DESIGN STANDARD REVIEW

STAFF REPORT & RECOMMENDATION DSR25-009 (Exhibit 1)

Project Number: DSR25-009

Project Name: Herzl-Ner Tamid Conservative Congregation PreK-8 Project (Barnabie Point Project)

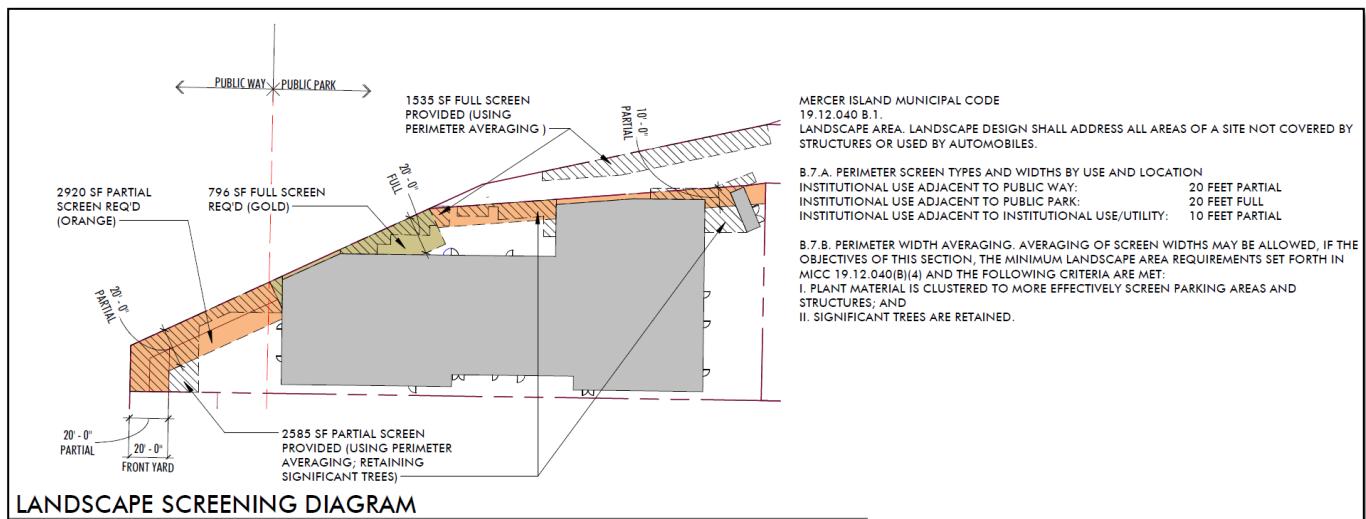
Staff Finding: The proposed screening is shown in the landscape screening diagram in **Exhibit 3, Sheet A-011** and below.

Staff Finding: The applicant proposes to include perimeter width averaging in the hatched areas shown in the landscape screening diagram in **Exhibit 3, Sheet A-011**. The proposed plant material would be clustered to more effectively screen the proposed structure while retaining some significant trees on the site.
